**Planning, Land Use and Mobility Committee
Case Report /Motion Reconsideration 11.18.20
DIR-2019-4531-DRB-SPP-MSP / Single Family Residence
4314 Canoga Drive
Woodland Hills, CA 91364**

Project Description: New Single Family Residence
Applicant / Rep: Ashraf Hemmati c. 310.709.3854; e:ashrafmemar@gmail.com
LA City Planner: Valentina Knox-Jones: 818.374.5038; valentina.knox.jones@lacity.org
Case Leader: Lauren Coffman / PLUM Chair / l.coffman@whcouncil.org
PLUM Meeting: October 3, 2019 / First Presentation
July 16, 2020 / Second Presentation
August 6, 2020 / Third Presentation
November 19, 2020 / PLUM reconsideration of Motion

BASEMENT FLOOR PLAN

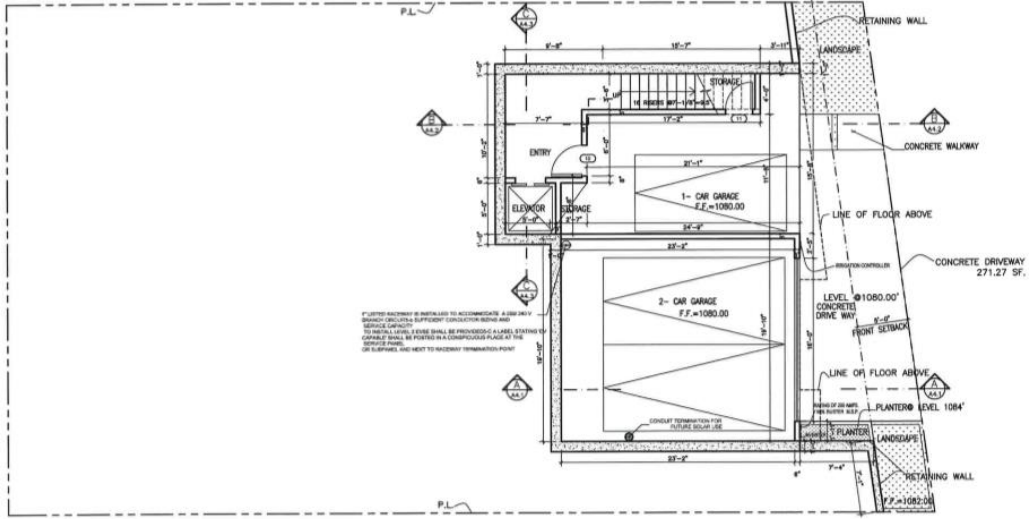
Two covered parking spaces are required. In addition, as per the Girard Tract, for each additional increment of 500 SF or fraction thereof of floor area, over 1,500 SF, there shall be one additional parking space or a maximum of 6 total on-site spaces. The add'l parking spaces may be uncovered and tandem. The project shows three covered spaces.

Site Plan

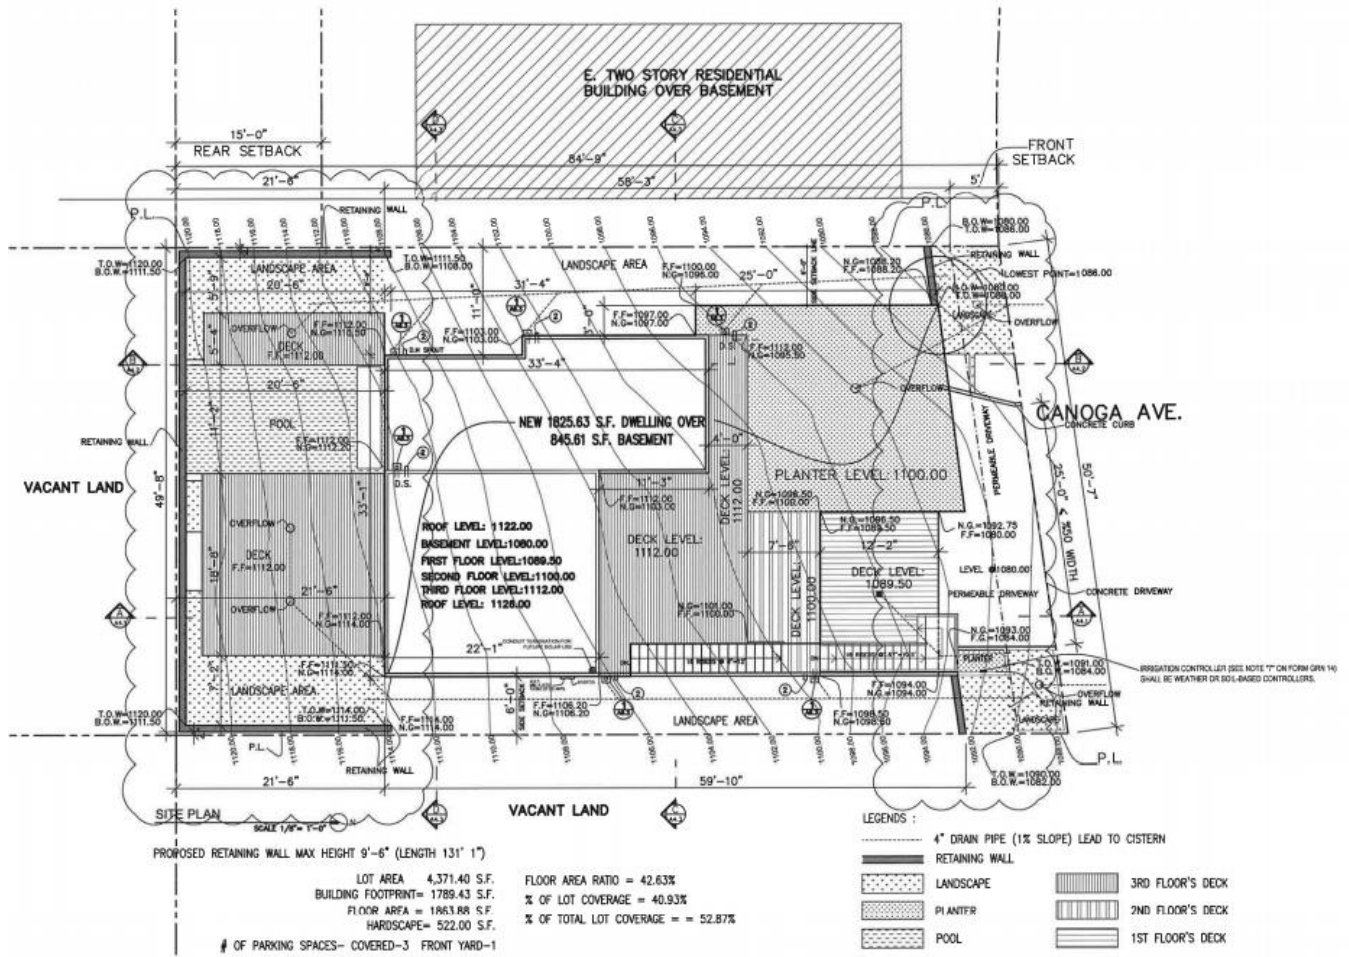
Site Drainage: Site drainage, is an issue for this site and the street, **Aside from the required planters, what is site drainage?**

1. Provide more information re: site drainage **8.6.20: Planters enlarged**
2. Locate hvac equipment on a site plan. Equipment will not be allowed on the flat roof(s) **8.6.20:Not shown**

Original Site Section

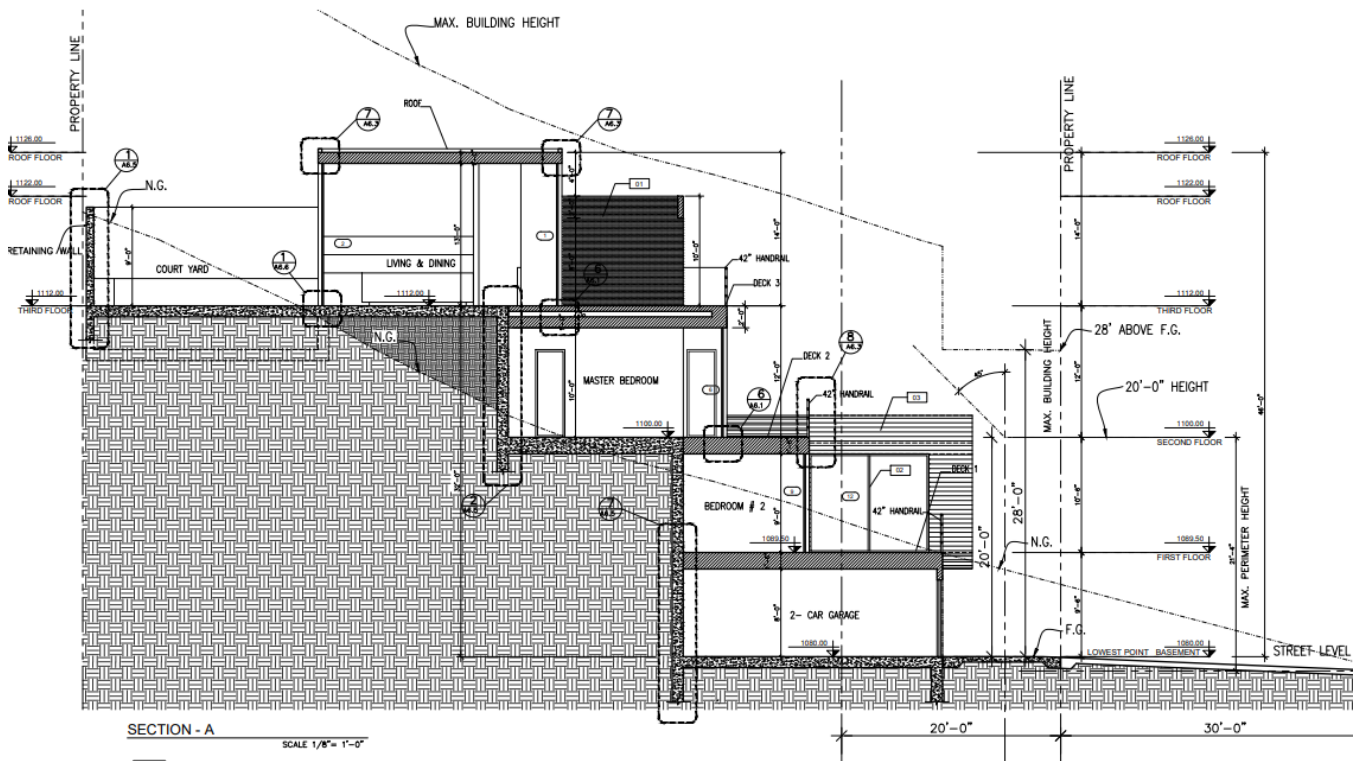
1. As per the Baseline Hillside Ordinance, the maximum envelope height for the R1-1 Zone, for a project with a roof slope less than 25% is 28 feet. This vertical height or “plumb line” height is originated at the lowest grade within 5 horizontal feet of the exterior walls of the building structure, and is the vertical distance from the grade of the site, to a projected plane at the roof structure or parapet wall located directly above and parallel to the grade.

2. The Overall Height is indicated as 50’ from finished grade to the top of the flat roof / parapet. This building appears to be taller than the allowed height of 45 feet by the *Baseline Hillside Ordinance*.

New Site Section

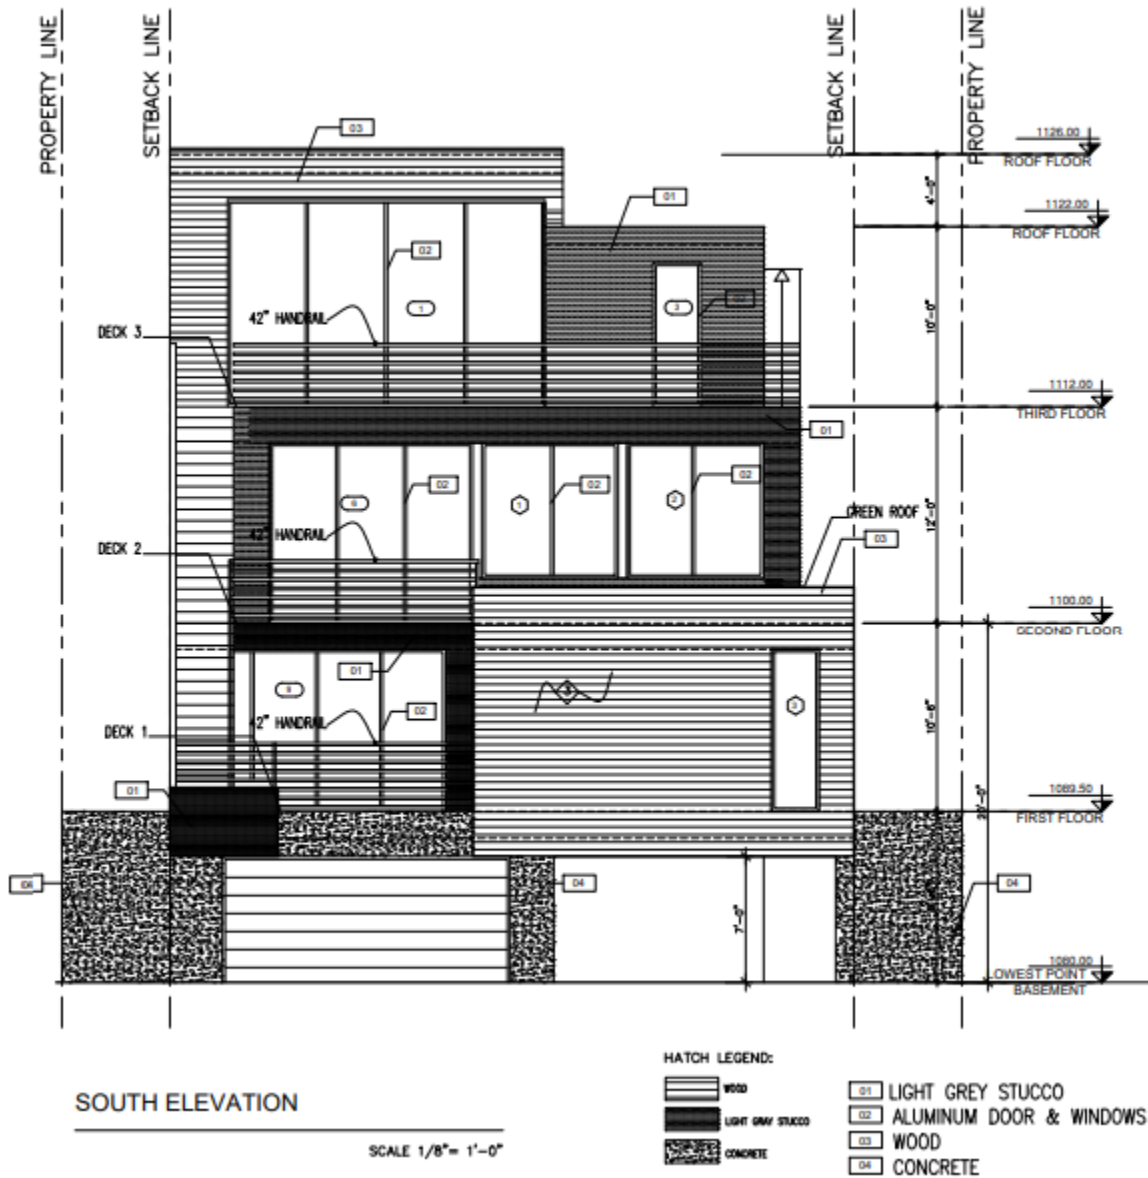
8.6.20 The projected plane needs to be 28’ from finished or natural grade, whichever is lowest. In the New Site Section, the projected plane includes a vertical cut line. This is not part of the projected plan, as it is a vertical cut in the projected plan, where the site is being cut back as needed to conform with the 30’ wide required street upgrade. As per the definition of grade in the baseline hillside ordinance, *For the purpose of measuring height on an R1, Rs, Re or RA zoned lot in the Hillside Area, pursuant to section 12.21.C.10 of this code, Hillside Area Grade shall be defined as the Elevation of the finished or natural surface of the **ground**, whichever is lower, or the finished surface of the **ground** established in conformance with a grading plan approved pursuant to a recorded tract or parcel map section.* The vertical cut of the ground should not be considered the grade. Therefore, the projected plan should be set at 28’ above the finished grade, which is the driveway.

8.6.20: As per the New Site section, which shows the street, the building seems to comply.
